Shell shape change for microSD Conn. Push-Pull H=1.28 with Detect Switch 504077-0891/1891

Model No.: 504077-0891/1891

Shape Change

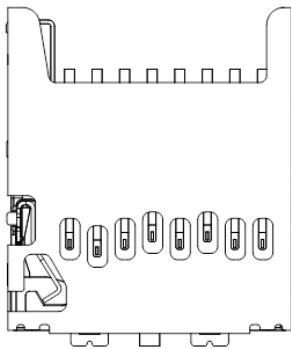
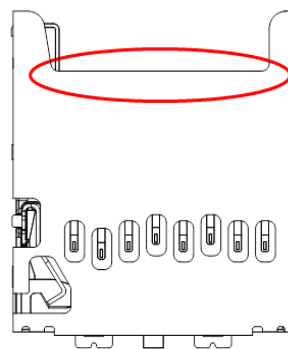
- From: <Currently used shell>
- Tail portion is exposed from the top connector.
- To: <New shell>
- It hide the tail portion from the connector top.
- The new shell has the effect as ESD countermeasure.

- About ESD, we must to implement the measures in the current products or more, to be able to use our customers with peace of mind.
